Sent: 9/06/2023 4:32:15 PM
Subject: FAO: Alex Keller - Objection letter re: Amended plans for DA2022/0646 at 122-124 Queenscliff Rd, Queenscliff
Attachments: AMENDED PLANS objection letter 122-124 Queenscliff Road Queenscliff-DA20220646.pdf;

**Submission to Amended Plans - Development Application DA2022/0646
Demolition works and construction of a residential flat building at 122-124 Queenscliff
Road, Queenscliff**

This submission is with regard to the Amended Plans submitted to Development Application DA2022/0646, dated 10 May 2023, on behalf of *Kristina Vikman* (my client).

Figure 3 – Addition of two further windows level 1 floor, east elevation facing my client's bedroom windows – direct window to window overlooking at a close proximity

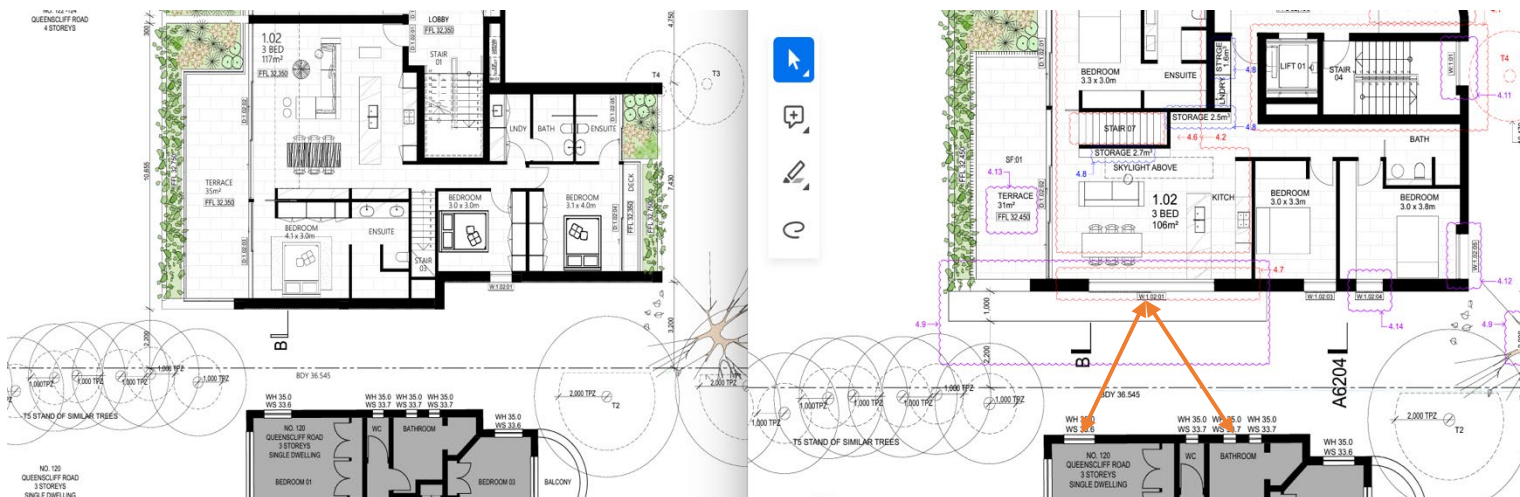
Amended plans include further unreasonable privacy impacts, as shown in figure 3. Expansive new windows opening are now proposed directly overlooking my client's property.

See amended compared to superseded plans drawing number A2203

- Suggested amendments to overcome the impacts on amenity including the following:
 - Pull back the side setbacks at the eastern elevation of the proposed development as the wall height increases and pull back the south eastern corner to assist with view sharing.
 - Remove the roof terrace and spa area proposed over the third storey (over Level 01).
 - Remove Level 01 or reduce the height to reduce the identified impacts.
 - Should Council approve the proposed development without requiring that Level 01 be removed, the internal layout of apartment 1.02 at Level 01 needs to be amended to remove the bedroom window.
